Work Order ID 61526

Item Name: Floor Protector, Fwd LH (Black)

DRAWING NO. D3281	TITLE FLOOR PROTECTOR	REV. E	DART AEROSPACE LTD ENGINEERING ORDER		D.E.O. NO. D3281-E-1	SHEET NO. SHEET 1 OF 1	SCALE NTS
DRAWN <i>q</i>	CHECKED <i>k</i>	MFG. APPR. <i>DL</i>	APPROVED <i>H</i>		DE APPR. <i>H</i>		
DATE 10.02.24	DATE 16.02.25	DATE 18/02/25	DATE 10.02.25		DATE 10.02.25

ADD "D3281-xL08" MATERIAL OPTION. EXISTING PARTS TO BE IDENTIFIED AS "D3281-xL02"

D3281-1 FLOOR PROTECTOR

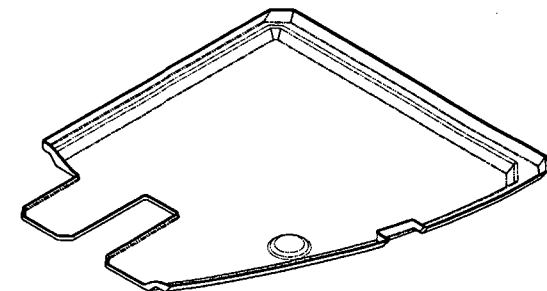
E	-3/4 NOW TRIMMED FLAT: RMV 0.25 BEVEL TO FACILITATE TRIMMING (ZN D6-3, D4-4)	CP	10.01.05
D	THICKNESS 0.093 WAS 0.125, MIN THICKNESS 0.070 WAS 0.080, P/N AND B/N ID WITH VIBRATING STYLUS (ZN A7-1, A7-2, A7-3, A7-4); D3281-4 NOW ON PAGE 4; CORRECT WEIGHTS (ZN A8-1, A8-2, A8-3, A8-4)	PH	08.03.28
C	UPDATE DIMS TO MATCH PARTS: COLOUR 701 WAS 700; GENERAL UPDATE	LE	07.10.09
B	NOW LEXAN; DIMS AS MANUFACTURED	CP	05.11.25
A	NEW ISSUE	CP	04.05.03
REV.	DESCRIPTION	BY	DATE
DESIGN	<i>JP</i>	DART AEROSPACE LTD HAWKESBURY, ONTARIO, CANADA	
DRAWN	<i>JP</i>		
CHECKED	<i>JP</i>	DRAWING NO.	REV. E
MFG. APPR.	<i>JP</i>	D3281	SHEET 1 OF 4
APPROVED	<i>JP</i>	TITLE	SCALE
DE APPR.	<i>JP</i>	FLOOR PROTECTOR	NTS
DATE	10.01.05	COPYRIGHT © 2004 BY DART AEROSPACE LTD THIS DOCUMENT IS PRIVATE AND CONFIDENTIAL AND IS SUPPLIED ON THE EXPRESS CONDITION THAT IT IS NOT TO BE USED FOR ANY PURPOSE OR COPIED OR COMMUNICATED TO ANY OTHER PERSON WITHOUT WRITTEN PERMISSION FROM DART AEROSPACE LTD.

D3281-1L08 FLOOR PROTECTOR (SHOWN)
D3281-2L08 FLOOR PRETECTOR (OPPOSITE)
 LOCATION OF ENGRAVING

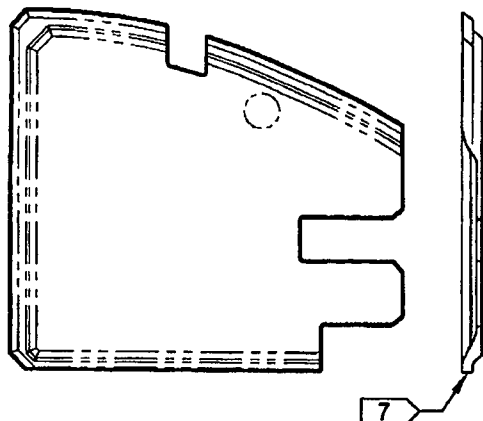
D3281-xL08 PARTS ARE EQUIVALENT TO THE RESPECTIVE "-x" PARTS EXCEPT AS DETAIL BELOW. THE MATERIAL, IDENTIFICATION, AND WEIGHT NOTES ARE AMENDED AS FOLLOWS:

- 7) IDENTIFICATION: IDENTIFY WITH DART P/N "D3281-xLxx" AND B/N "Bxxxxx" ON SMOOTH SIDE OF PART USING VIBRATING STYLUS.
 FOR -xL08 PARTS, LOCATE ENGRAVING ALONG PERIMETER OF PART AS SHOWN.

- 2) MATERIAL: -xL02 = LEXAN F6006, BLACK No. 701, 0.093" THICK (MLEXS.093-F6006-02)
 -xL08 = LEXAN 90318 (PROTECT-A-GLAZE), 0.118 THICK, 112-CLEAR (MLEXS.118-90318-08)

- 8) WEIGHT: D3281-1L02/-2L02 = 0.95 lb D3281-1L08/-2L08 = 1.13 lb
 D3281-1L02/-2L02 = 0.87 lb D3281-3L08/-4L08 = 1.05 lb
